Memo

Application: Z10-0075

Address: 2960 Appaloosa Rd

Subject: Rezoning Application

Draft rezoning and subdivision plan

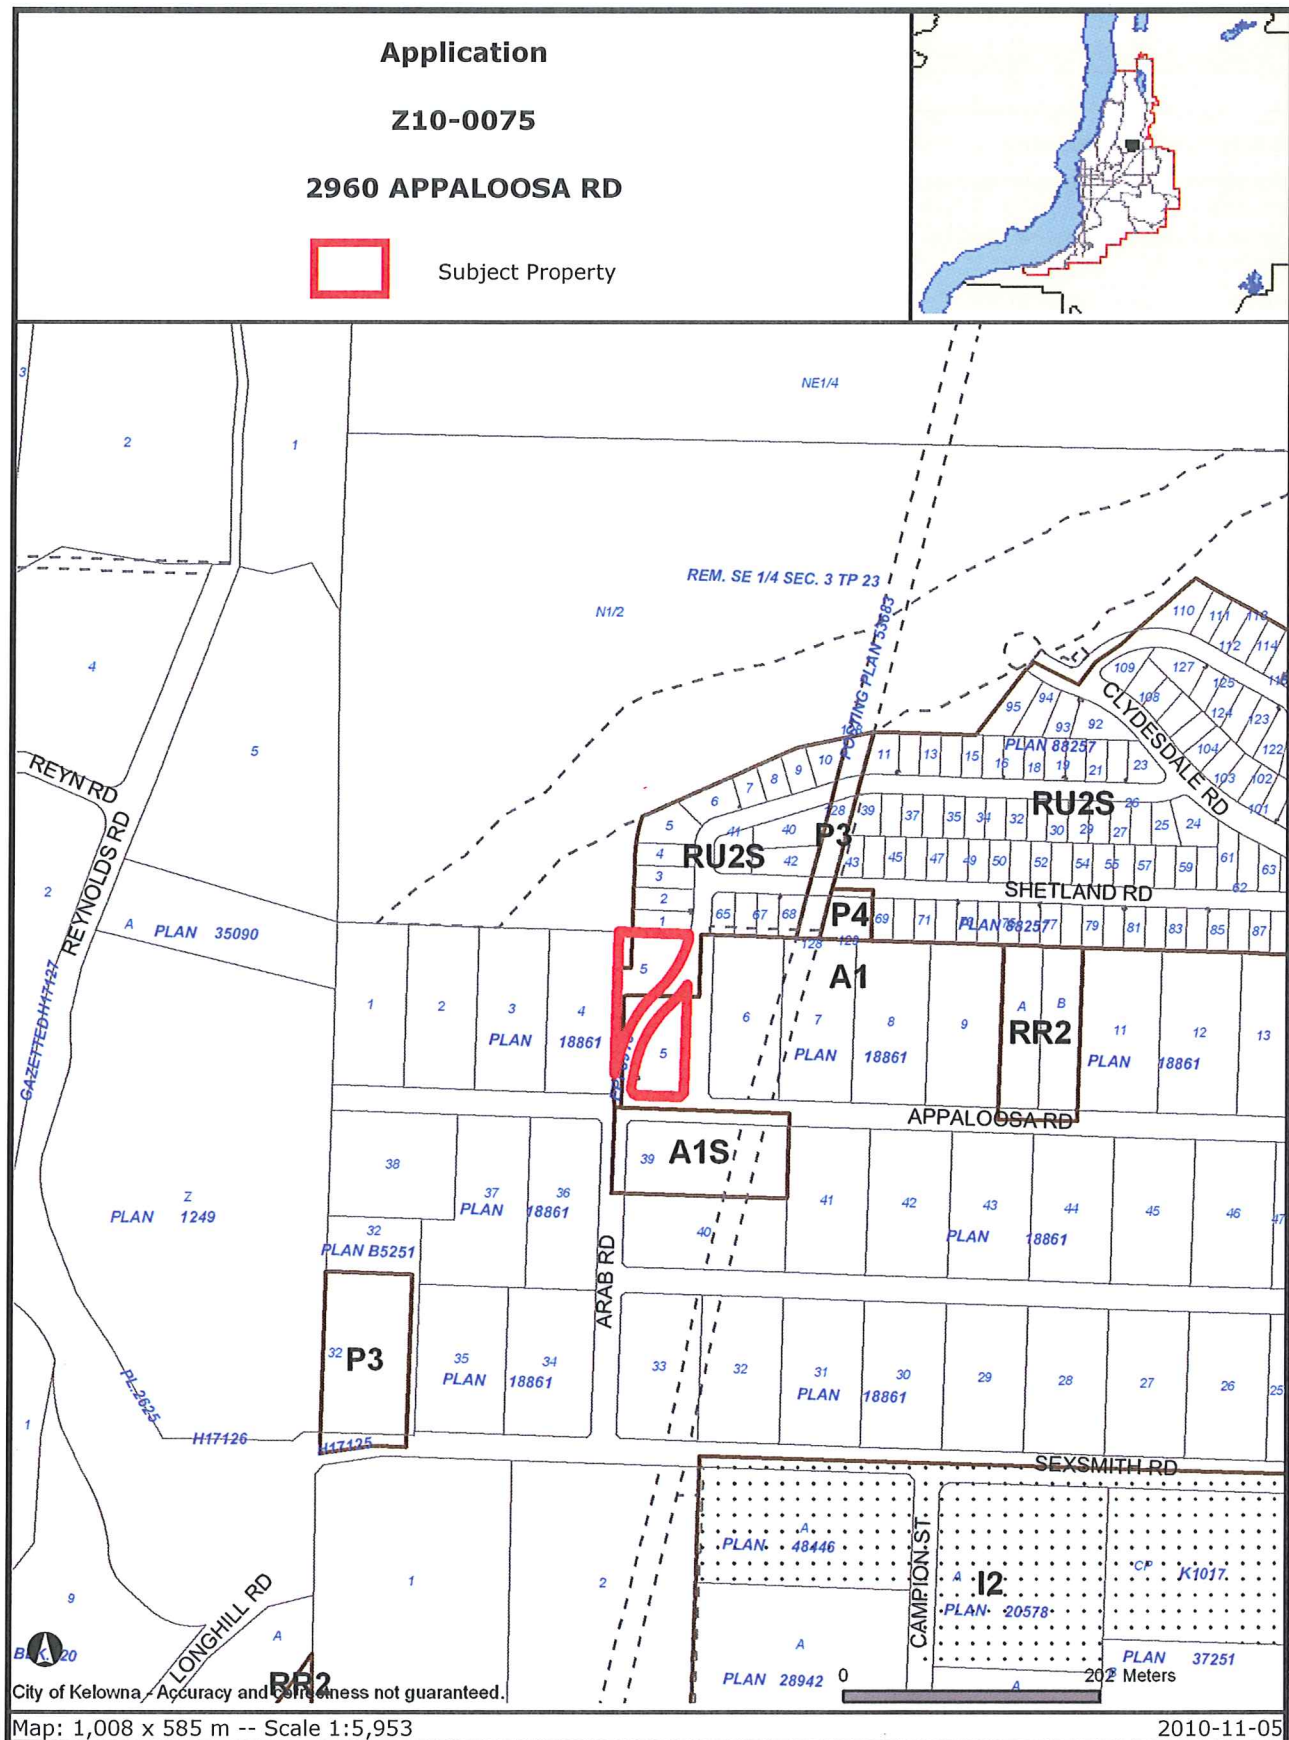
Dedicate the required land to provide a SS-R4 standard for the extension of Arab Road through the subject property.

- a) Arab Road fronting these properties has been constructed to a Minor Collector standard (SS-R4) including curb, gutter and sidewalk, piped storm drainage system, fillet pavement, street lights.
- b) Appaloosa Road fronting these properties must be constructed to a full urban collector standard complete with curb and gutter, sidewalk, storm drainage system, fillet pavement, street lights, and adjustment and, or re-location of existing utility appurtenances if required to accommodate this construction.
- c) The original Arab Road to the east of lots 1,2 and 3 will require a turnaround at the north end. It should also be noted that the Street name will need to be changed.
